Corridor 121-221

Rock Springs Bypass Corridor

Corridor Purpose and Rationale

Figure 3. Map of Conflict Areas in Vicinity of Corridor 121-221

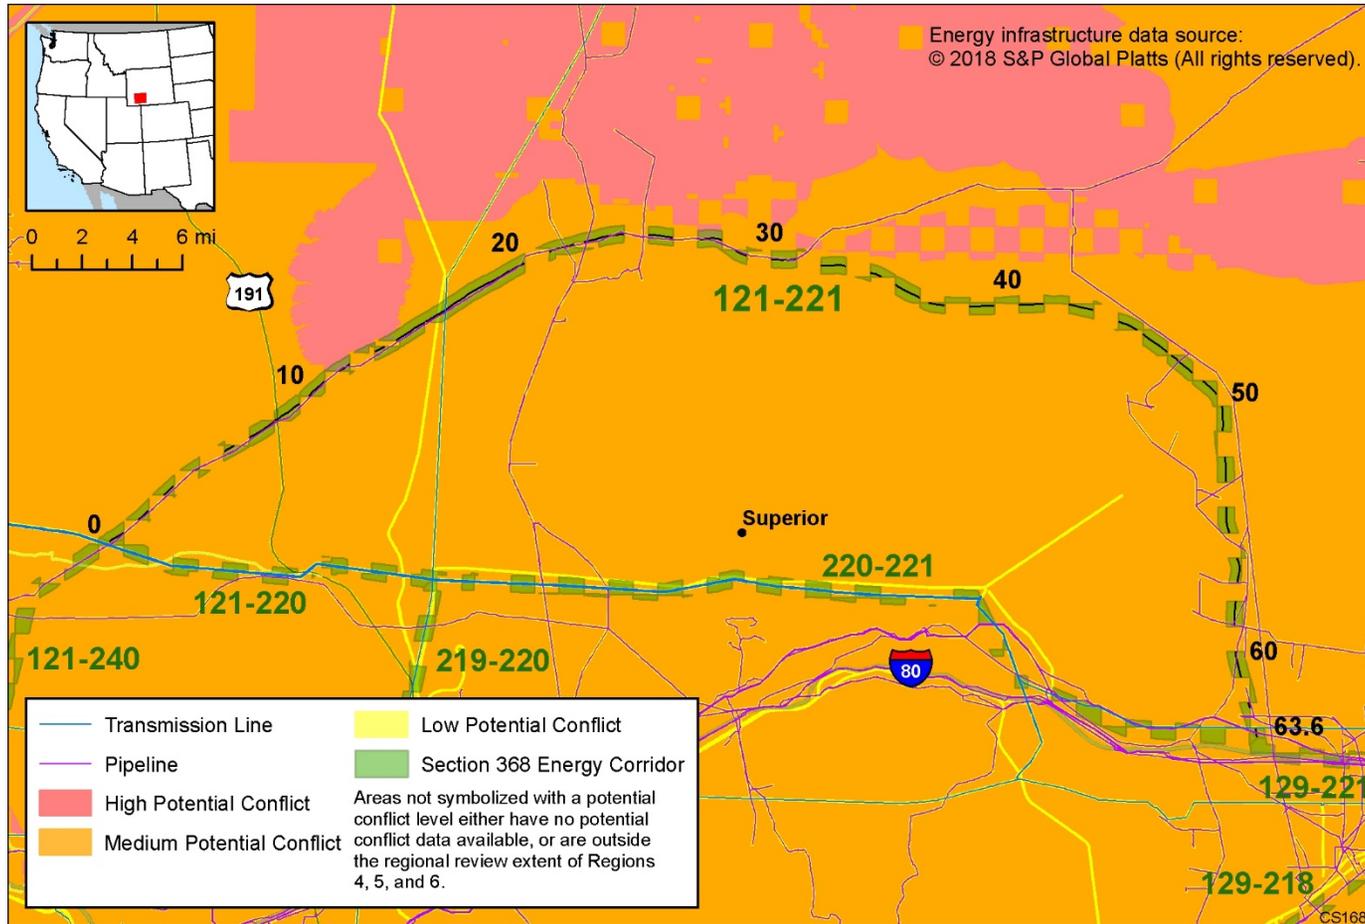
Figure 3 reflects a comprehensive resource conflict assessment developed to enable the Agencies and stakeholders to visualize a corridor’s proximity to environmentally sensitive areas and to evaluate options for routes with lower potential conflict. The potential conflict assessment (low, medium, high) shown in the figure is based on [criteria](#) found on the WVEC Information Center at www.corridoreis.anl.gov. To meet the intent of the Energy Policy Act and the Settlement Agreement siting principles, corridors may be located in areas where there is potentially high resource conflict; however, where feasible, opportunity for corridor revisions should be identified in areas with potentially lower conflict.
